4160 Doniphan

City Plan Commission — August 14, 2025

SITE PLAN

CASE NUMBER: PZDS25-00016

Figure A. Site Plan Superimposed on Aerial Imagery

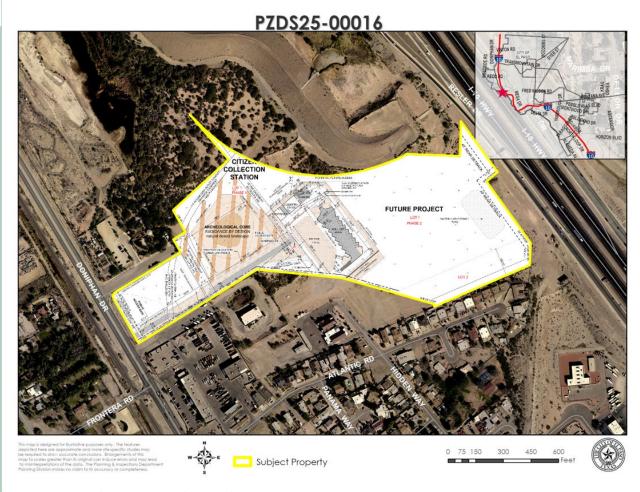
2. No building(s) shall be constructed closer than fifty (50) feet to the southerly property line adjacent to St. Judes Church and the Pacific Park Subdivision.

4. An additional twenty (20) foot wide special building setback line shall be established adjacent to the twenty (20) feet of right-of-way being dedicated in Condition No. 3 of this contract.

No building(s) or structure(s) shall be constructed within the special building setback line, except that surplus off-street parking shall be allowed.

6. There shall be no vehicular ingress and egress from this property to Hidden Way.

Note: Proposed development complies.

Note: Proposed development complies.

Note: There is no vehicular ingress and egress to Hidden Way.
